From: Guy Rochez [REDACTED]
Sent: 24 March 2021 14:37
To: Nicola Moore
Cc: Planning.Responses; andrew bridges
Subject: Re: Request for further information FG/46/21/PL
Attachments: 028_Plans Existing Proposed.pdf; FG_46_21_PL202103241155136546.pdf

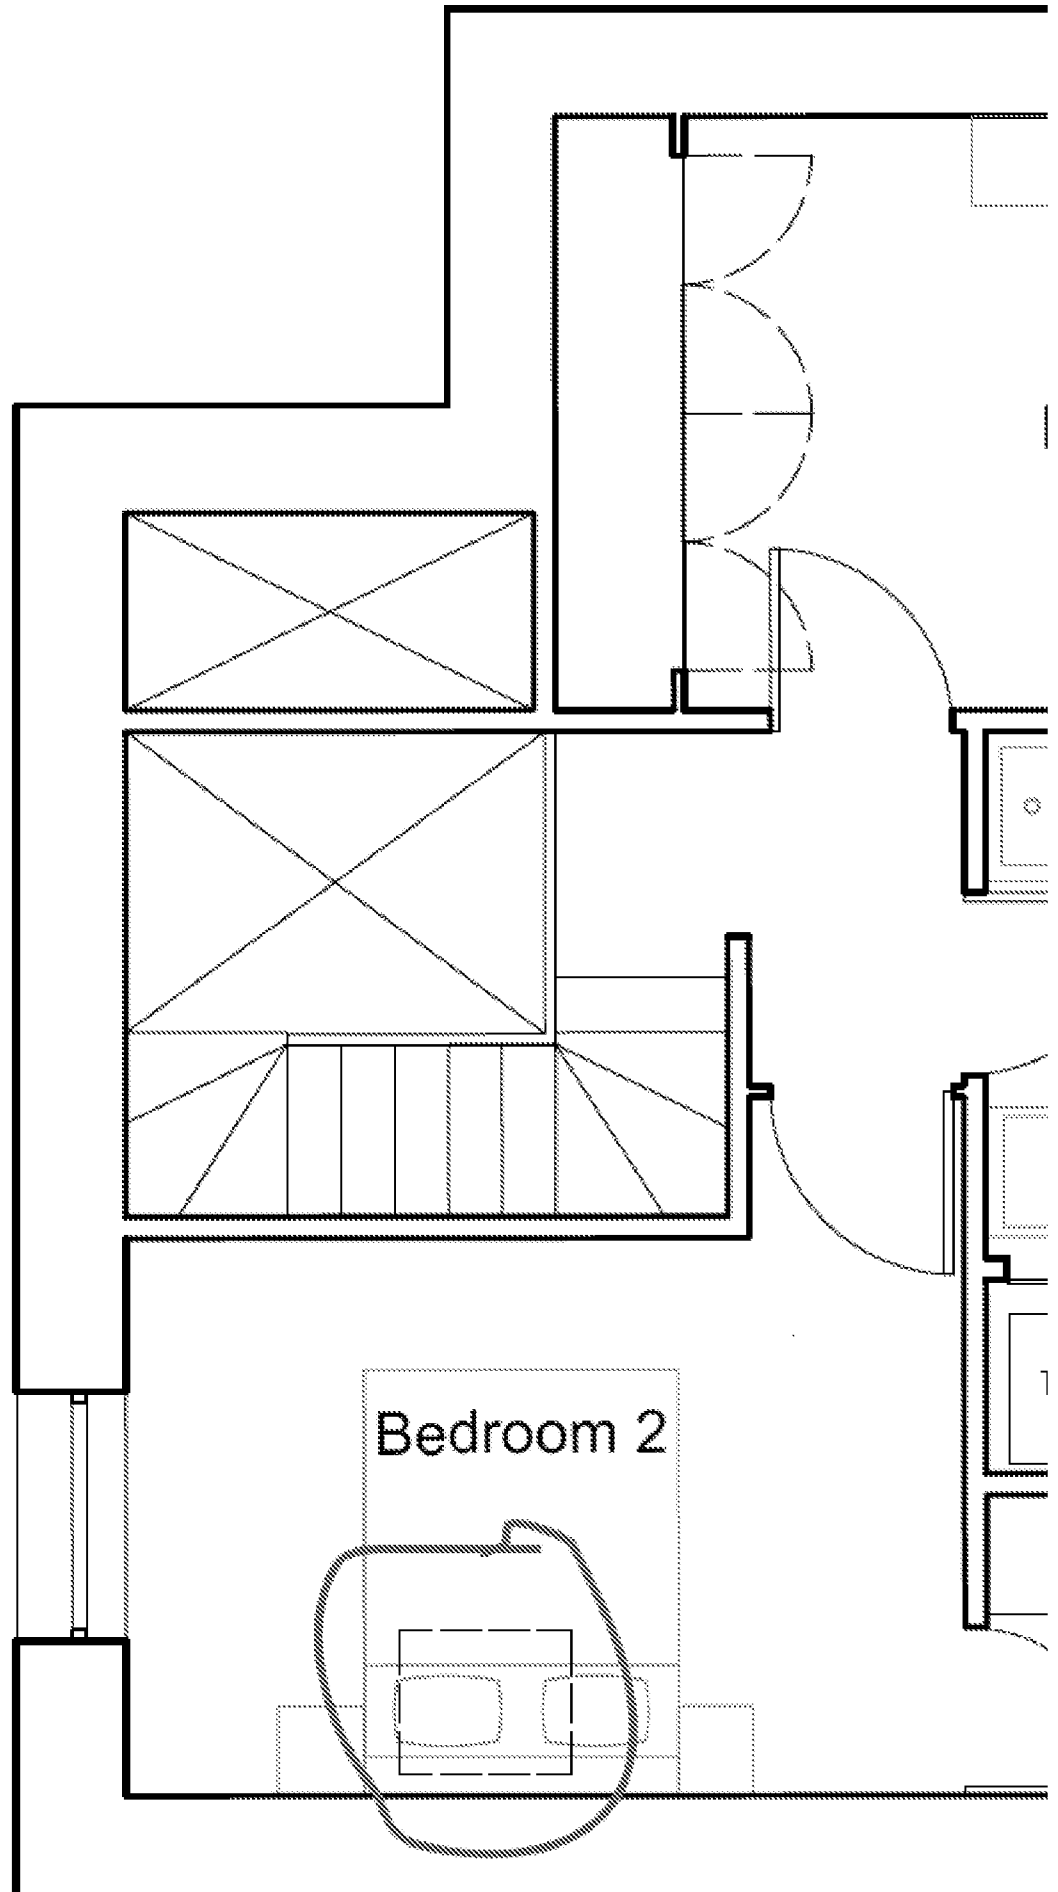
Further to the email below stating that only 2 out of 3 roof lights are identified on the first floor plan, I have checked the set of drawings I issued to you this morning and re-attach to this email, and there are 3 roof lights shown on the first floor plan. For clarity I provide the screenshot below with a red circle around each.
